RE: August 3, 2003 Municipal Water Licence Report

Arctic Bay Inspection 2003

MUNICIPAL WATER USE INSPECTION REPORT

Licence No.: NWB3ARC0207

Photo 1. Water Supply Intake Facility, water sample N 72.5931.7 W 85.0048.5.

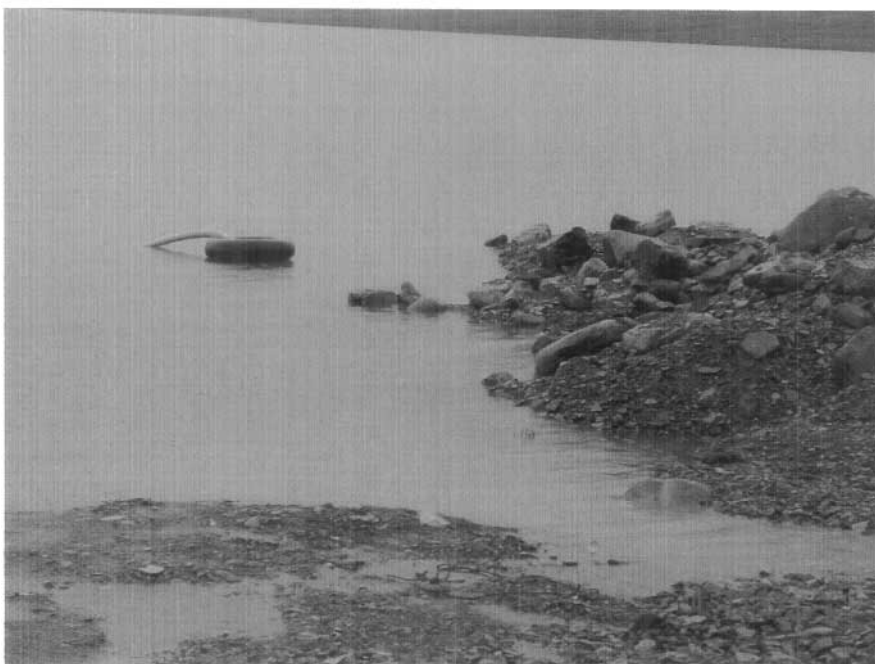
The Water Intake Facility is fairly well maintained however there is garbage around the Water Intake Facility (photo 3-5). Signs are required at the Water Intake Facility to alert the public that no boating or fishing are allowed on Marcil Lake. The Inspector noted oil staining at the Water Intake Facility ruck fill station (photo 2). This stained soil shall be removed and a Spill Kit shall be placed at the Water Intake Facility to reduce the potential of contaminating the water supply. Secondary containment shall be provided

for the Water Intake Facility fuel oil supply (photo 1). The NWB shall be contacted for authorization prior to the removal and remediation (land farming) of the contaminated soil.

Photo 28. Spillway shown in berm #2, shown operating due to improper material in berm.

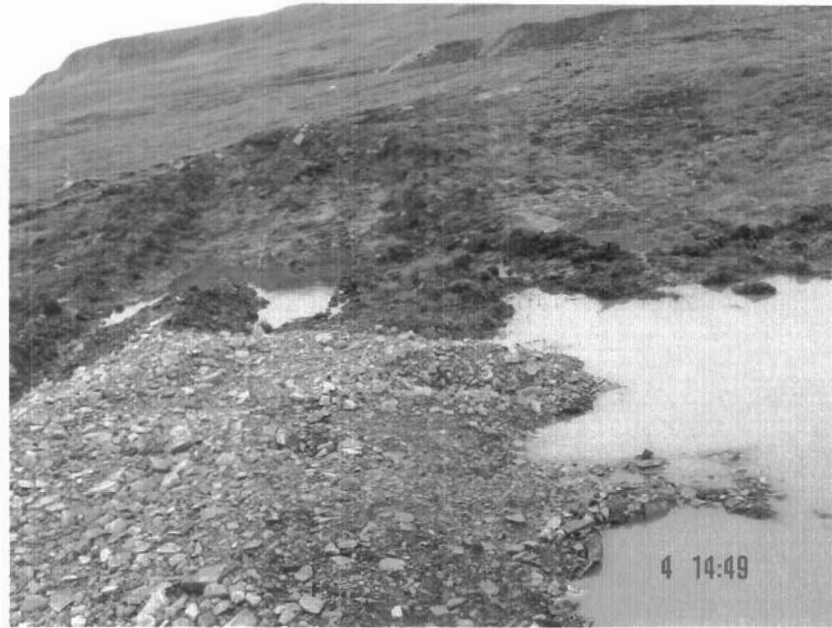
On May 13, 2003 the (New - Lagoon) berm was breached. The WRO Inspected the Sewage Lagoon failure in May 22, 2003. The municipality had put the (Old - Sewage Lagoon) into use prior the WRO attending the site. The WRO noted on May 22, 2003 excessive sewage effluent flow emitting from the (Old - Lagoon). On August 5, 2003 during the Water Licence Inspection the WRO observed seepage at an estimated (180 L/m) emitting from the (Old - Lagoon) at (photo 13 & 14). The WRO requested Arctic Bay take immediate measures required to reduce the excessive Sewage Lagoon seepage to an acceptable amount. Under direction of the WRO the Licencee and there contractor were unable to reduce the seepage from the (Old - Lagoon). Dave Parker of Community Government & Transportation (CG&T) advised the municipality to breach the berm between the Old and New Lagoon. This berm breach drained the (Old - Lagoon) into the (New - Lagoon) and ceased the excessive seepage from the (Old - Lagoon). The (New Sewage Lagoon) was then put into use. On October 22, 2003 the WRO was informed by CG&T of the wetlands treatment area build up of ice, due to leakage from the (New-Lagoon). The WRO contacted CG&T and was informed that the excessive seepage condition would be alleviated when the berm freezes latter in the year. The WRO observed on August 4, 2003 the Wetlands Sewage Treatment area was not operating as designed (photo 14 - 30). The Solid Waste Disposal Facility is a fairly well maintained burn and burial operation. The tipping face is kept to a minimum. The bulky metal waste has been buried in 2003 (photo 33). Waste oil drums require consolidation (photo 34), waste batteries are well stored in a sea lift container (photo 35). The Dump and adjacent Sewage Lagoon - Wetlands Treatment area are not fenced.
